PCN Supporting Data Package

PCN#: 20260611001.1

Title: Qualification of TIEM as an additional Assembly site for select devices

June 2026

Assembly Characterization Data – 2DPY package:

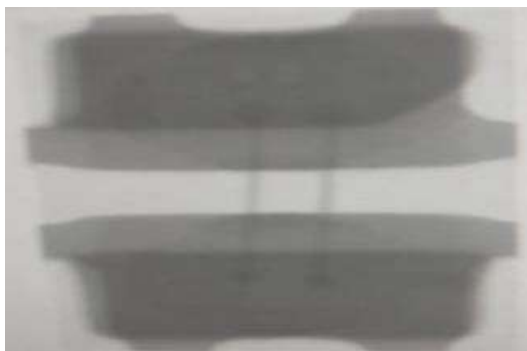
Purpose	Assembly MQ
Device	ESD761DPYR
Package type/Pin Count	DPY/2
Results	PASS
Notes

Assembly Data	Sample size	Units of measure	USL	LSL	Manufacturability Data			
					Average	Std Dev	CpK	Remarks
Ball Shear	76	gmF	0	9.5	27.66	2.05	>1.67	PASS
Die Shear	30	gmF	2.5	0.065	65.37	12.12	>1.67	PASS
Wire Pull	76	gmF	0	2.5	8.40	0.68	>1.67	PASS

Cpk values > 2.0 are 6sigma limits with DPPM rates of less than 0.00198 (parts per million) and exceed the TI Quality Guidelines.
